AGENDA

ARCHITECTURAL REVIEW BOARD MEETING
CITY HALL, 385 SOUTH GOLIAD STREET, ROCKWALL, TEXAS
AUGUST 25, 2026 IN THE CITY COUNCIL CONFERENCE ROOM AT 5:00 PM

PROJECT NUMBER: SP2026-031
PROJECT NAME: Site Plan for 1041 E. Interstate 30
SITE ADDRESS/LOCATIONS: 1041 East Interstate 30, Rockwall, TX, 75032

DEPARTMENT	REVIEWER	DATE OF REVIEW	STATUS OF PROJECT
PLANNING	Bethany Ross	08/20/2026	Approved w/ Comments

CITY PROJECT # SP20##-####
SITE PLAN
FOR
1041 E INTERSTATE HWY 30
LOT 11, ROCKWALL BUSINESS PARK, EAST SUBDIVISION,
CITY OF ROCKWALL, ROCKWALL COUNTY, TEXAS

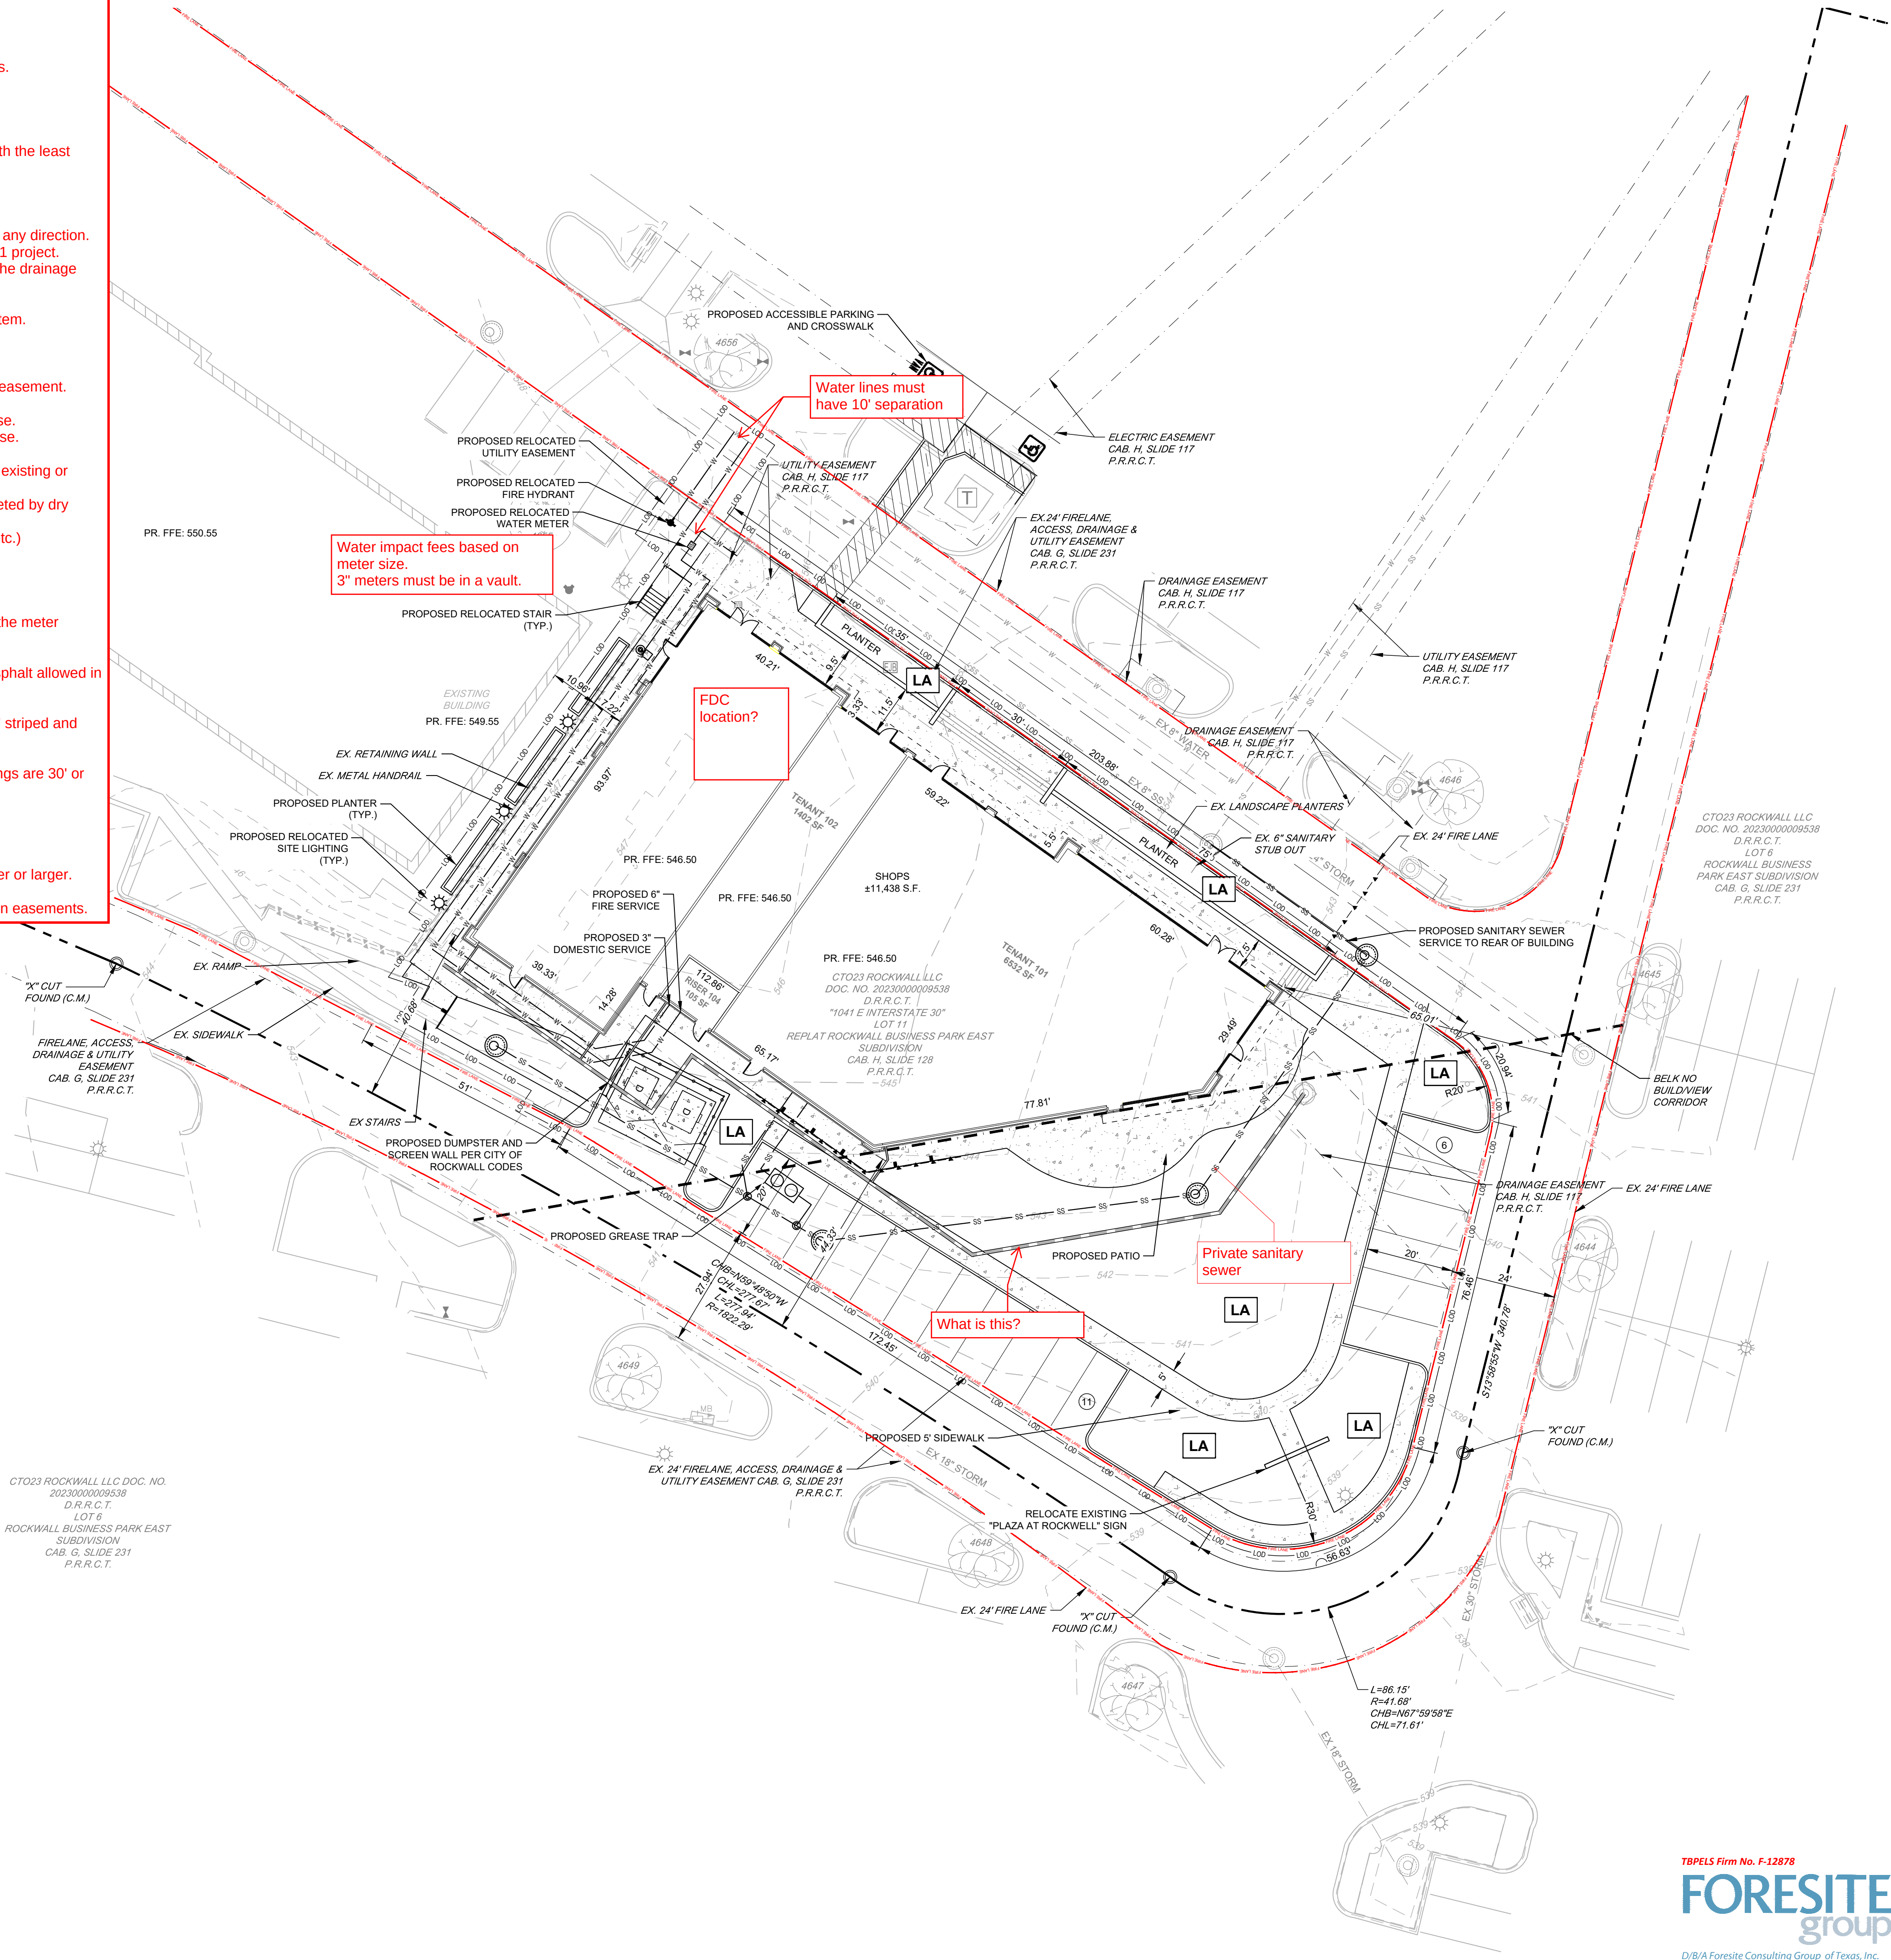
M.7 Site Plan

- 1) The plaza area cannot be removed. It was a part of a previous site plan (i.e. SP2010-007 & SP2013-003) approval and associated with variances to the code. Remove this area from your site plan.
- 2) Indicate all perimeter dimensions of the site. (Subsection 03.04.B, of Article 11, UDC)
- 3) Indicate distances between the building and property lines. (Subsection 0.04.B, Article 11, UDC)
- 4) Indicate building setbacks. (Subsection 0.04.B, Article 11, UDC) Front = 15', Rear = 10', Side = 10'
- 5) Patio associated with a restaurant? Patio parking is 1 parking space per 4 seats. (Article 06, UDC)
- 6) All parking shall be 20' by 9'. Provide dimensions of a typical parking space. (Subsection 05.03, Article 06, UDC)

1041 E INTERSTATE 30
ROCKWALL, TX

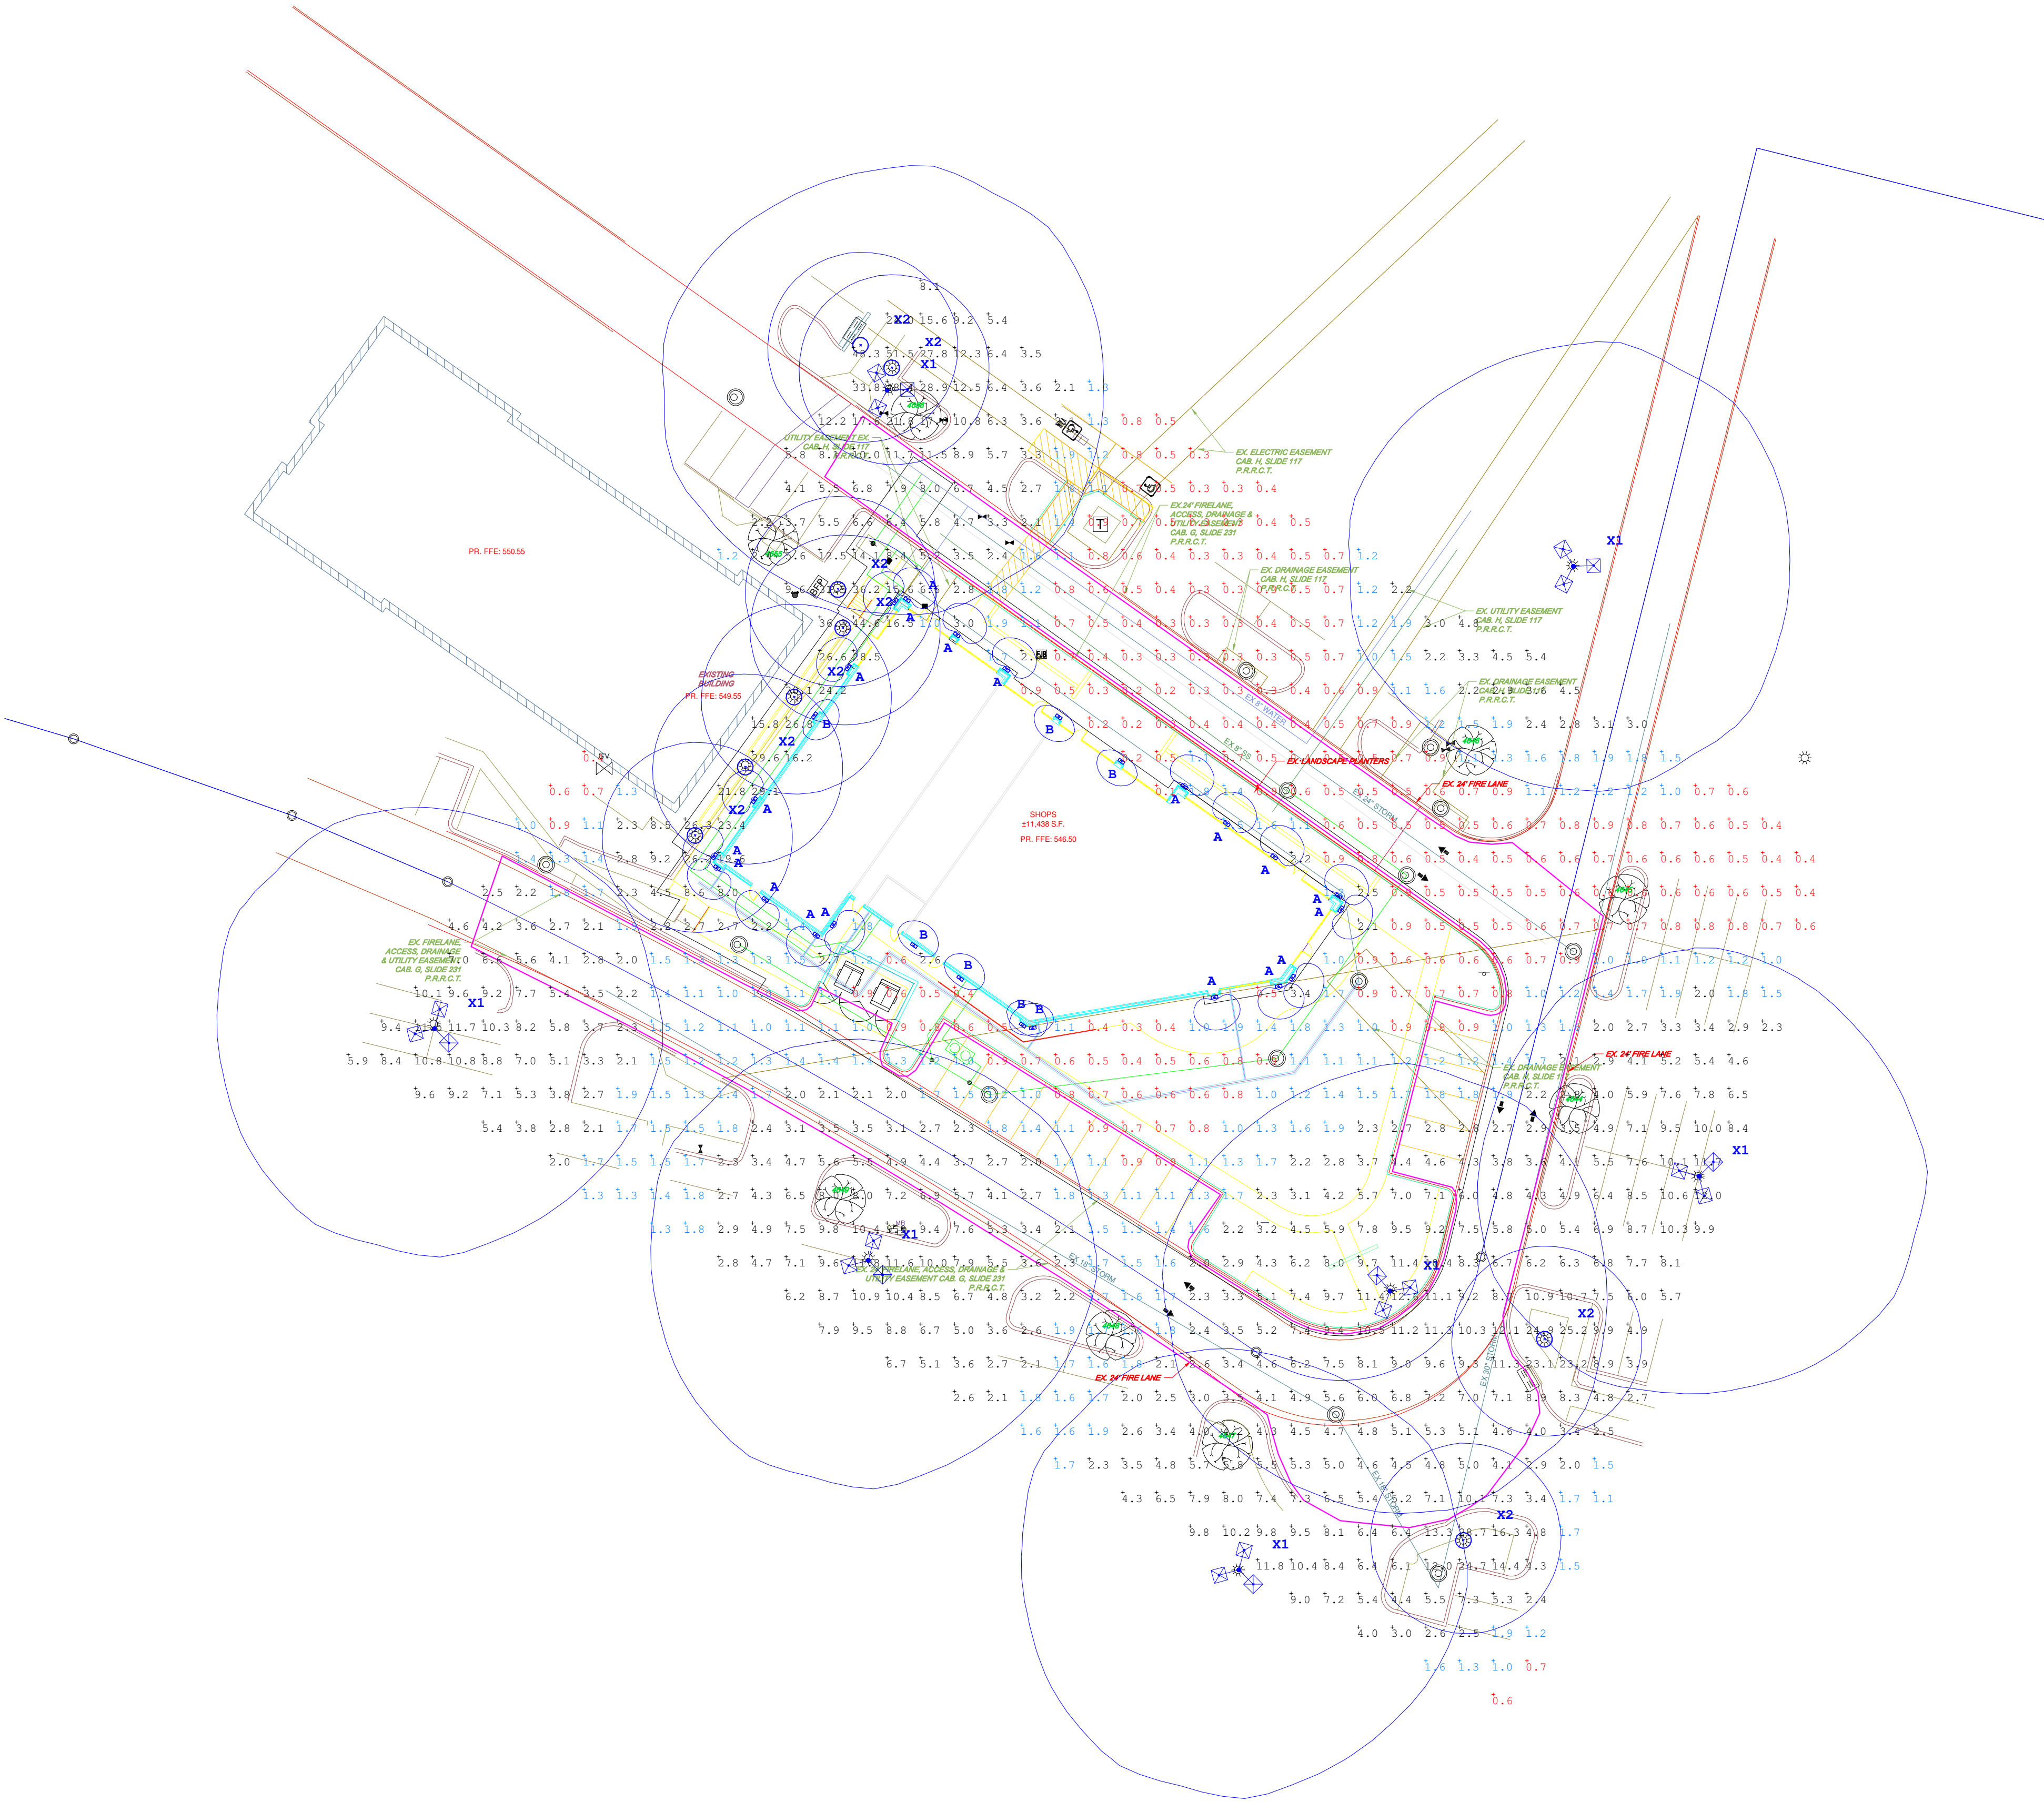
M.10 Photometric Plan

- 1) The maximum mounting height for lighting shall be 20 feet in the IH-30 Overlay District (Subsection 06.02.G, Article 05, UDC) Please indicate mounting height for all lighting.
- 2) Any unshielded light sources shall have a maximum wattage of 15 W. (Subsection 03.03.A, of Article 07, UDC)
- 3) All lighting sources shall be oriented down including those placed on the building. (Subsection 03.03.A, Article 07, UDC)
- 4) Do not show existing lighting sources from adjacent properties. The photometric plan should only show proposed lighting. The maximum outdoor illumination level at the property line is 0.2 FC. This will require an exception if not remedied.
